Re: Railway (Metrolink - Estuary to Charlemont via Dublin Airport) Order [2022]
Metrolink. Estuary through Swords, Dublin Airport, Ballymun, Glasnevin and City Centre to
Charlemont, Co. Dublin

RE: SUBMISSION ON THE METROLINK ON BEHALF OF JERDIP PROPERTIES UNLIMITED COMPANY IN
RELATION TO PROPERTY AT THE ARTHUR COX BUILDING, 10 EARLSFORT TERRACE, DUBLIN 2,
D02T380

Project Title	Project Metrolink – The Arthur Cox Building	From	Robert Coughlan, PUNCH Consulting Engineers
Project No	222273	To	An Bord Pleanála
Subject	Technical Submission to Railway (Metrolink–Estuary to Charlemont via Dublin Airport) Order 2022 at The Arthur Cox Building, 10 Earlsfort Terrace Dublin 02 T380	Cc	
Date	12-01-2023

**Appendix D – Drawings Indicating the Proposed
Metrolink on Plan beneath the Building and Full
Section Showing the Tunnel in Close Proximity to
the Building**

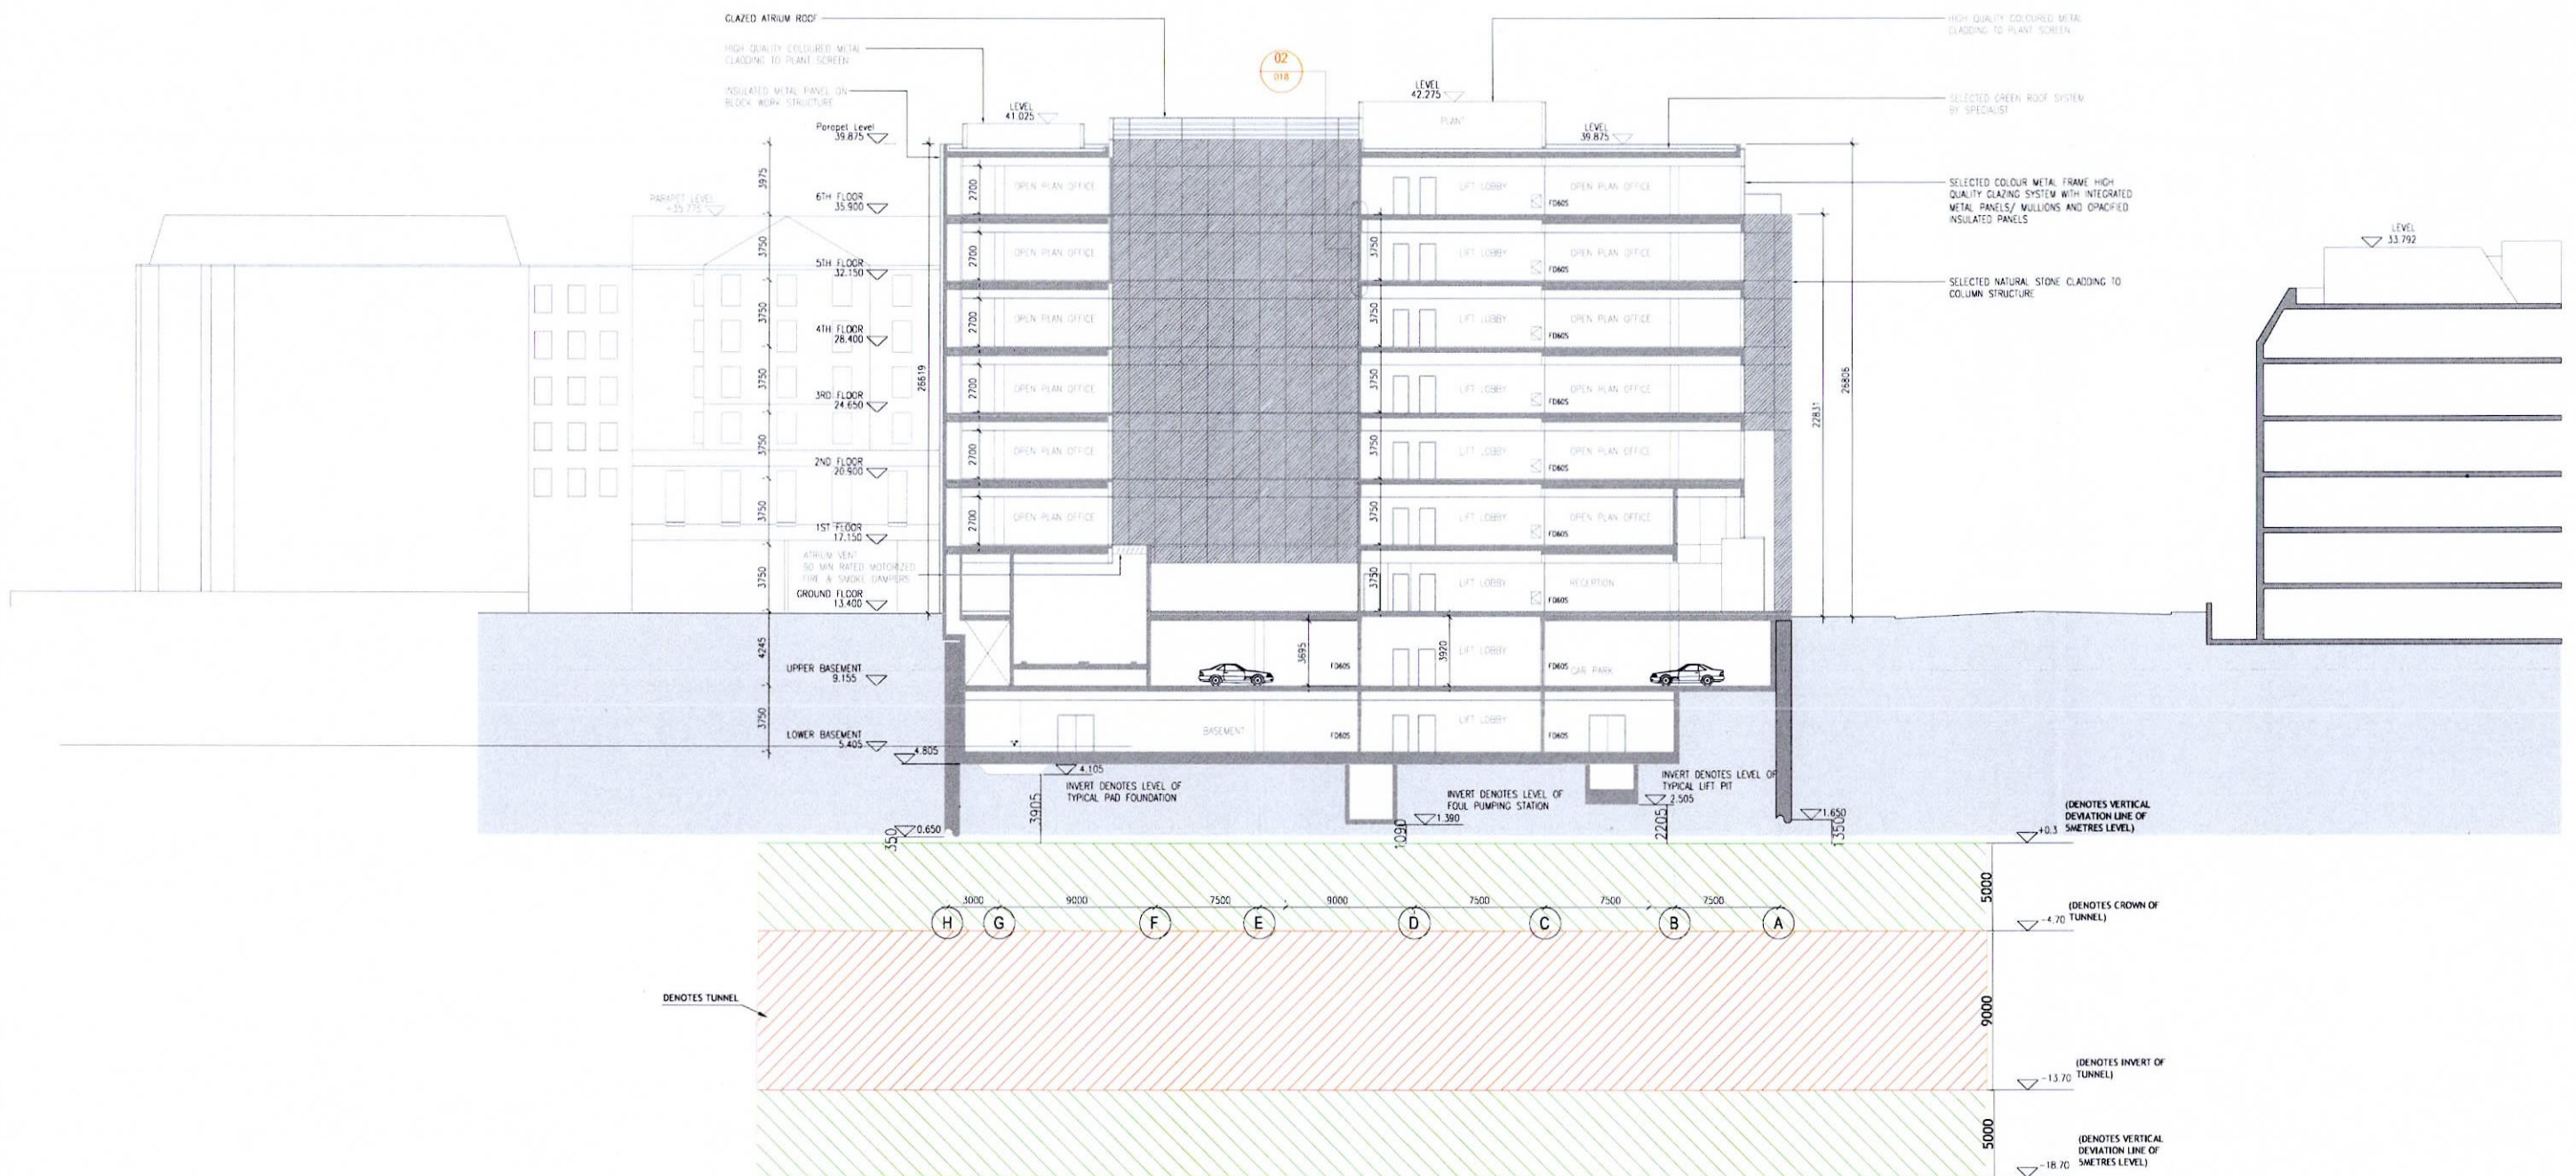
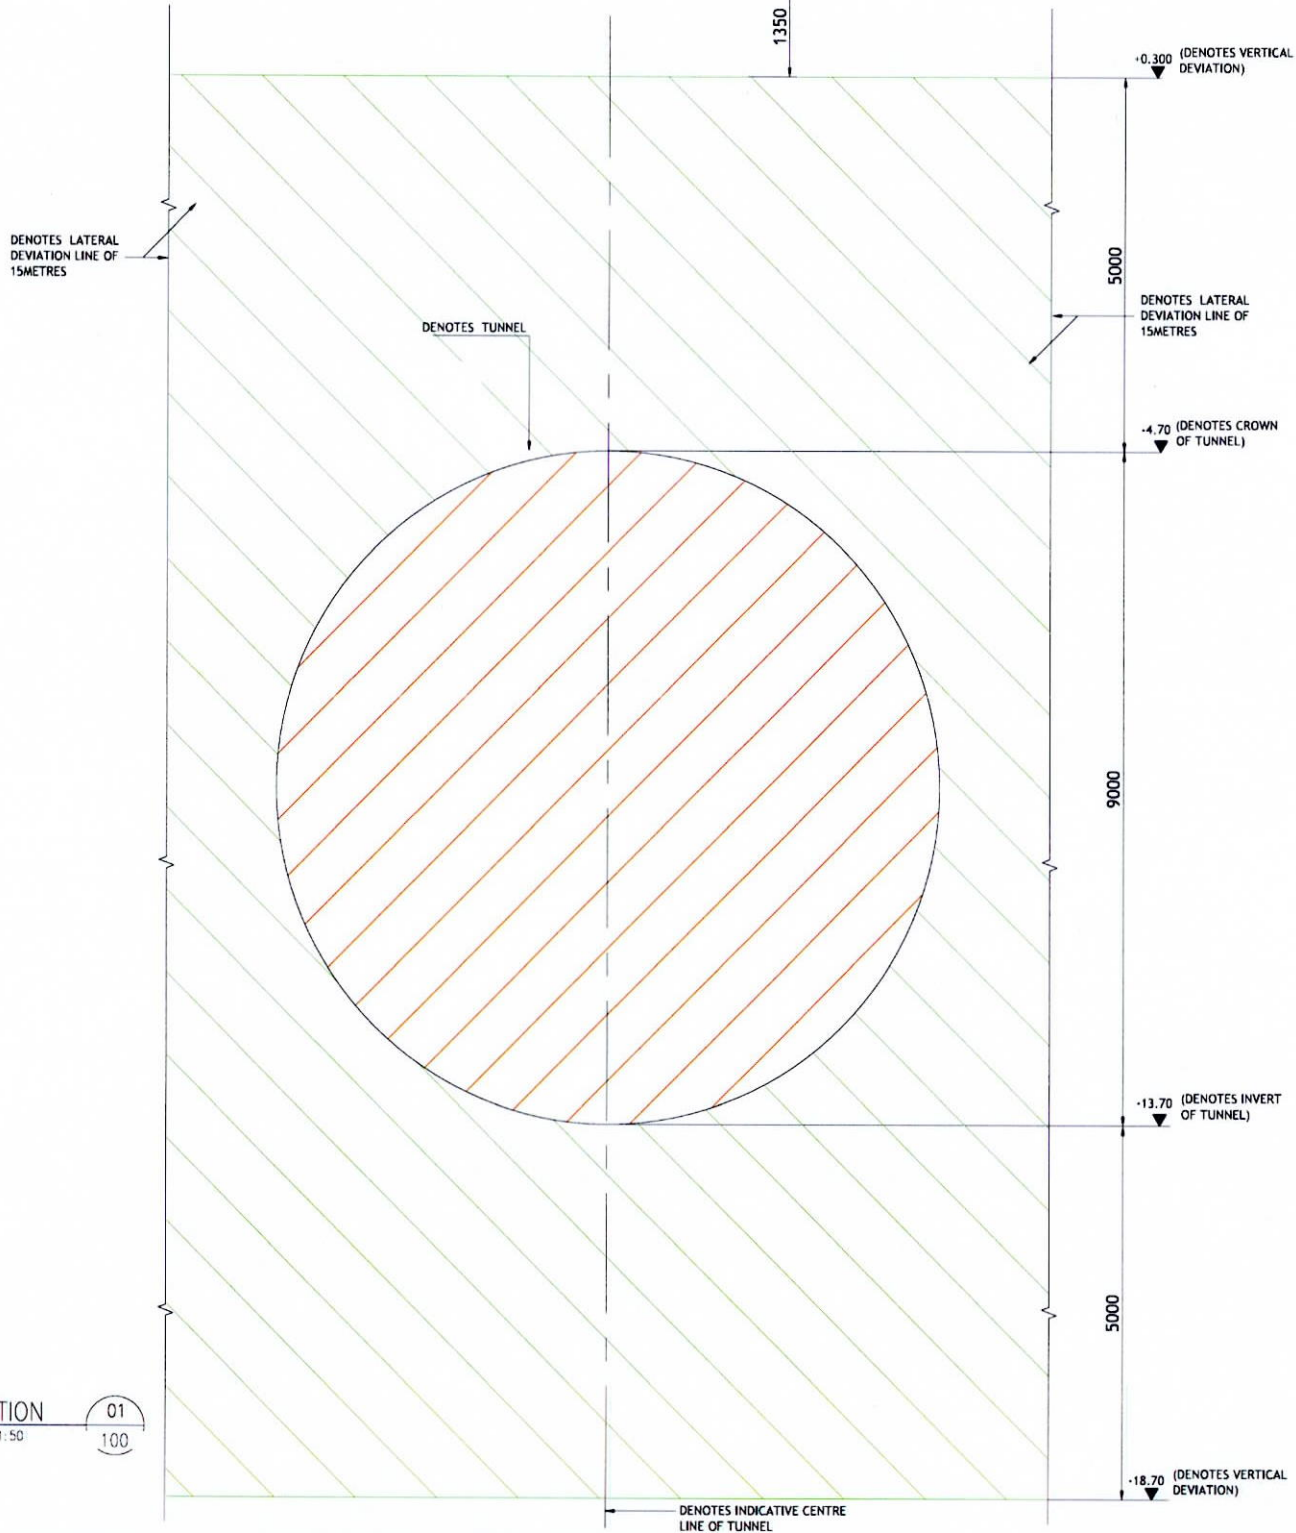
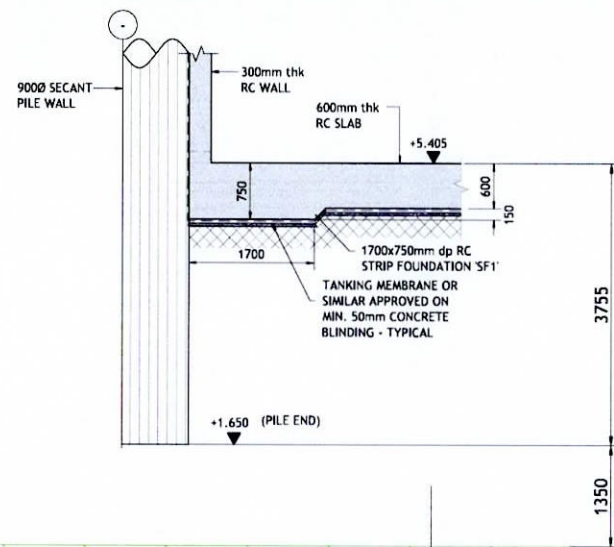
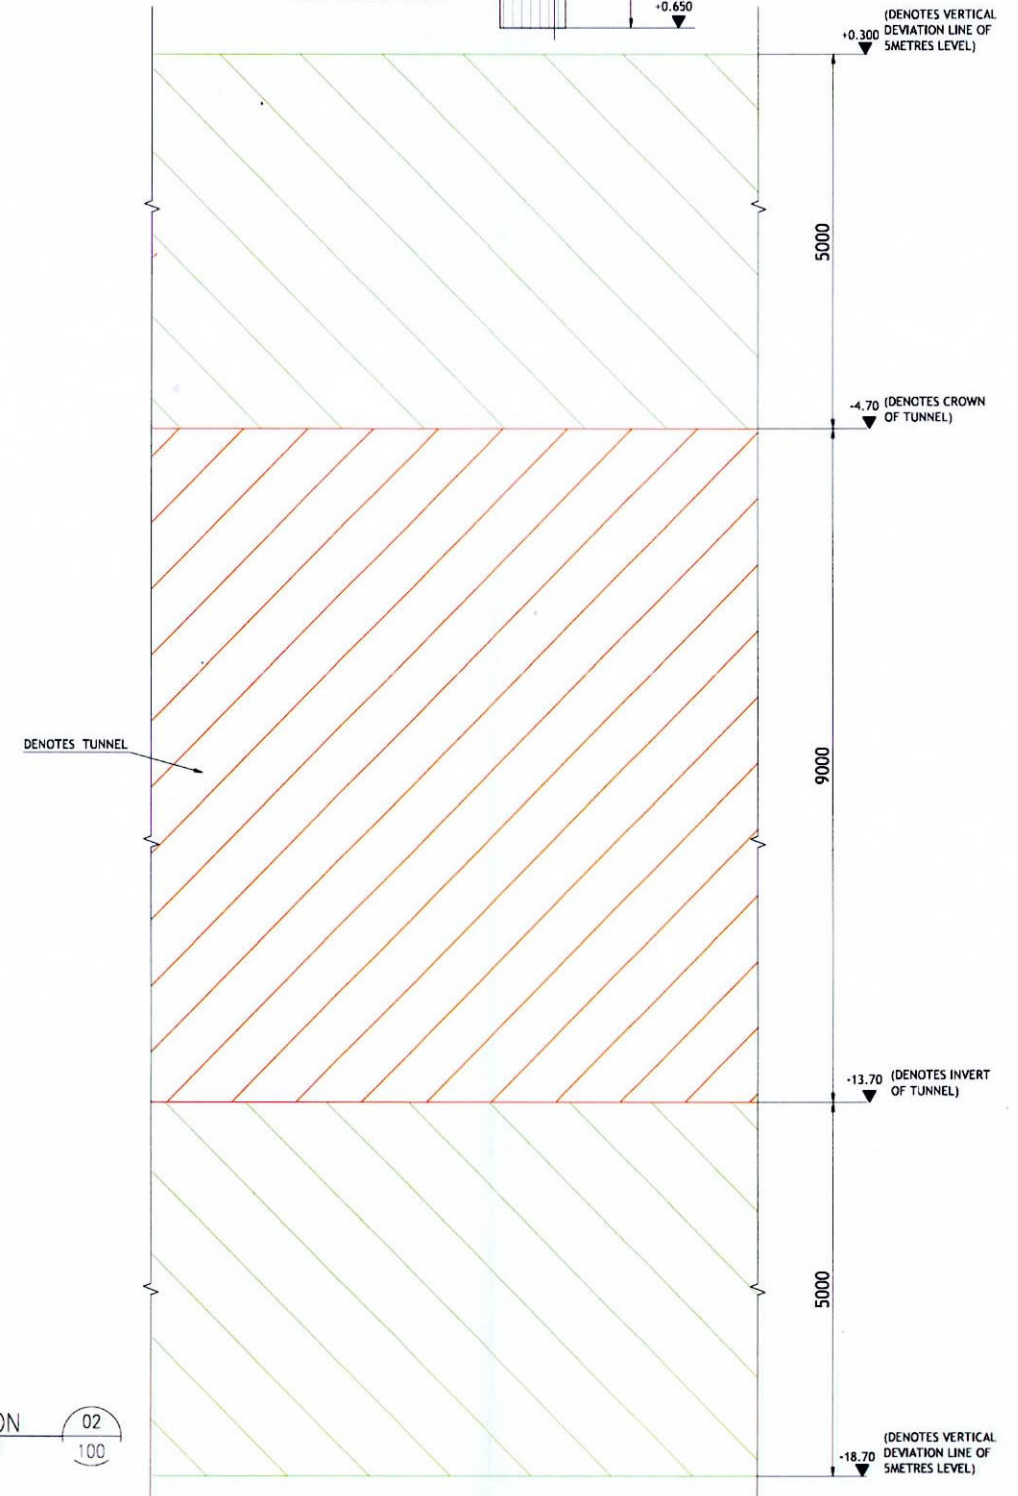
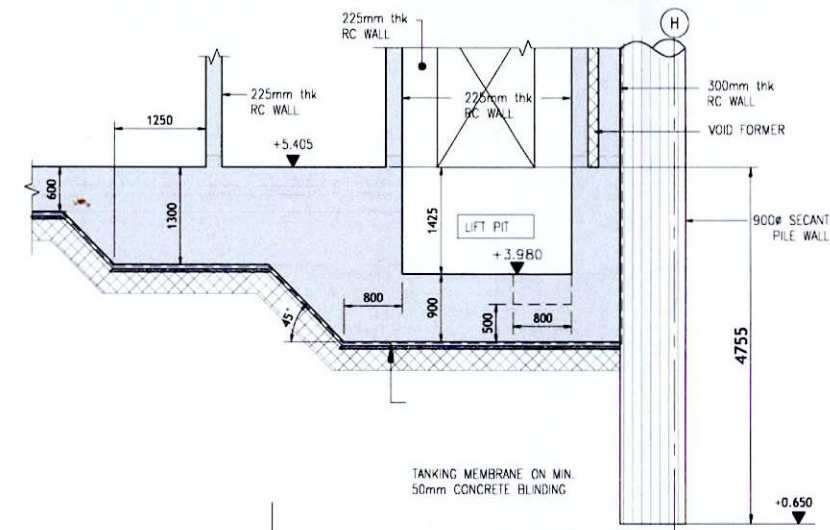
- i) We have concerns about the proposed tunnel level relative to that of the double basement structure and secant piled wall of 10 Earlsfort Terrace. Refer Appendix D of this submission for drawings illustrating the close proximity of the tunnel to the existing basement structure.
- ii) The proposed tunnel is approximately 6m below the lowest structural element and 5.35m below the lowest pile level. This proximity of significant engineering works to the underside of the structural support for The Arthur Cox Building is of serious concern.

- iii) The existing double basement is waterproofed with a Rascor White Tank Injection System and relies solely on the reinforced concrete structure to prevent water ingress. Hence, this form of waterproofing is very sensitive to ground movements and the design of the tunnel must take this into account.
- iv) The basement structure is below the water table level and the basement slab is very sensitive to vibrations and any adverse cracking to the slab would cause significant water ingress issues.
- v) We request that TII comment on each of the items above and confirm the integrity of the building will not be compromised by the proposed works
